TECHNICAL MEMORANDUM

Title: Technical Criteria Variance Application

Name: Castle Rock Industrial Park – Freeboard in Rockfall Mitigation Channel

Number: TCV19-0021 and CD16-0019

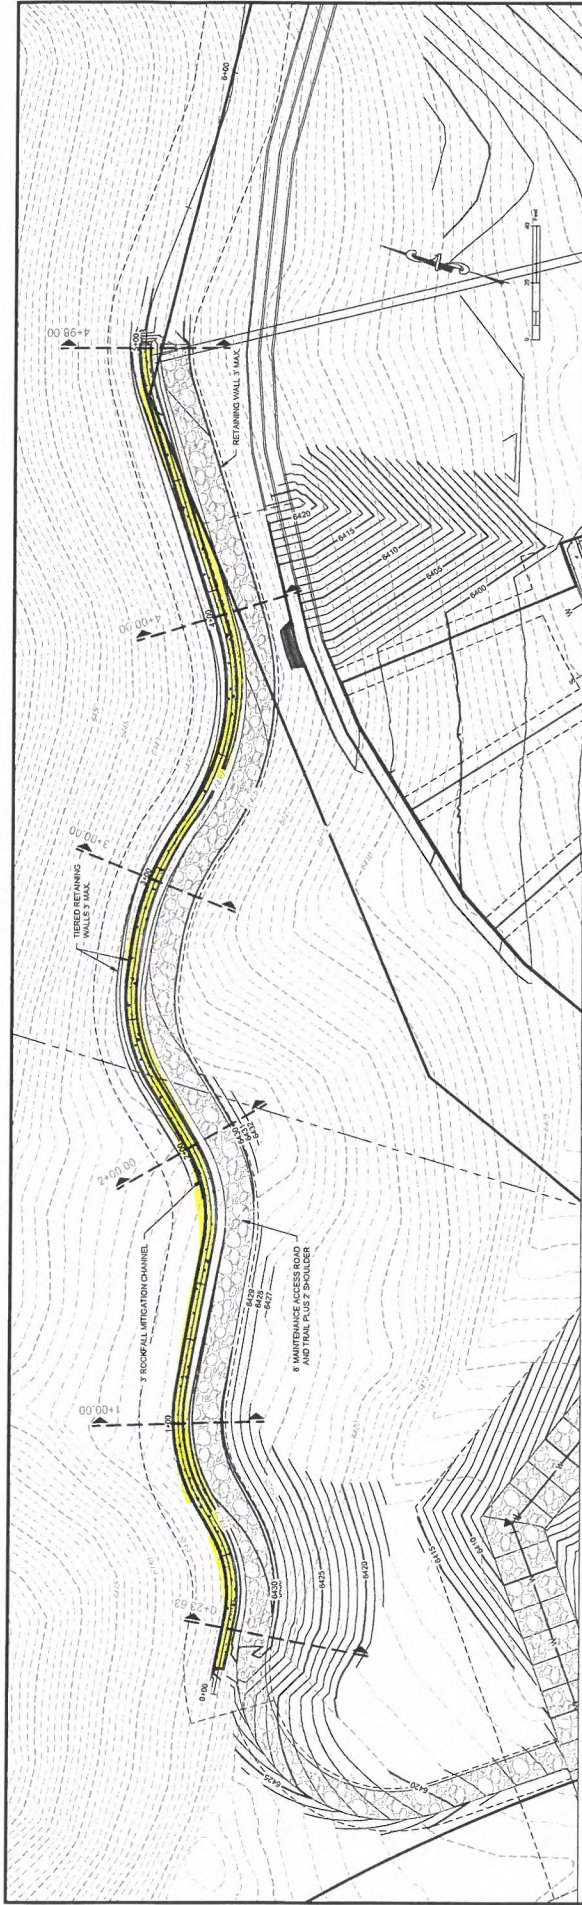
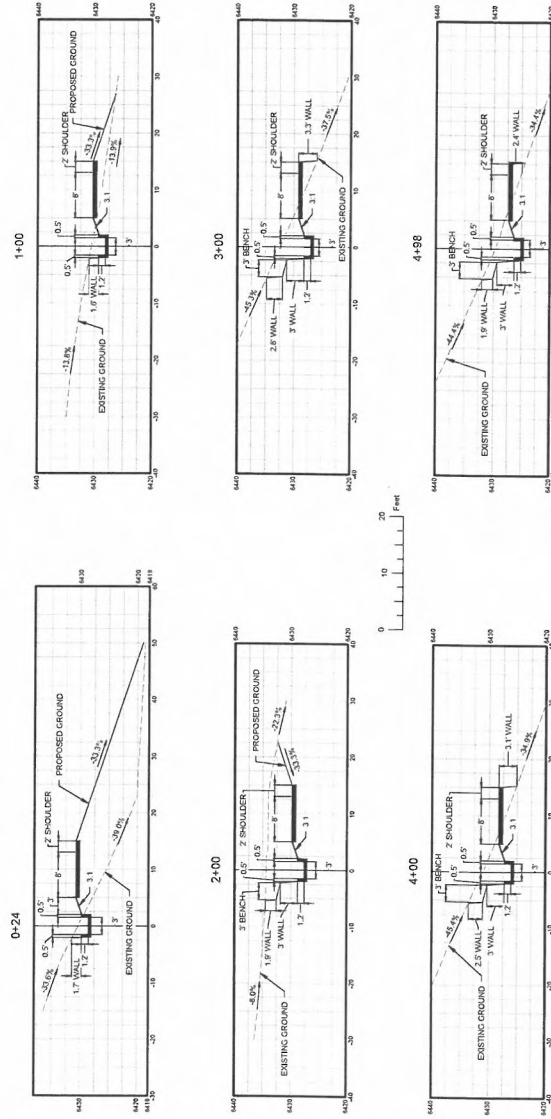
A variance is requested to reduce the required freeboard from 2-feet to 1-foot for the proposed rockfall mitigation channel.

Achieving 2-feet of freeboard along the entire rockfall mitigation channel is not feasible because in many areas the existing grade is steeper than 3:1 slopes.

A. In many areas along the proposed rockfall mitigation channel the existing grade is steeper than the maximum slope of 3:1 required by TOCR design standards, which means that tying into the existing grade would be impossible without extreme measures.

Recommendation: X **Approve**

1.0 foot of freeboard provided by a 3:1 embankment will be sufficient for protecting the community and will function as intended. Maintenance access is also optimized by reducing the total freeboard. Therefore, using 1.0 feet of freeboard will not cause adverse impact to public health, safety, or welfare.
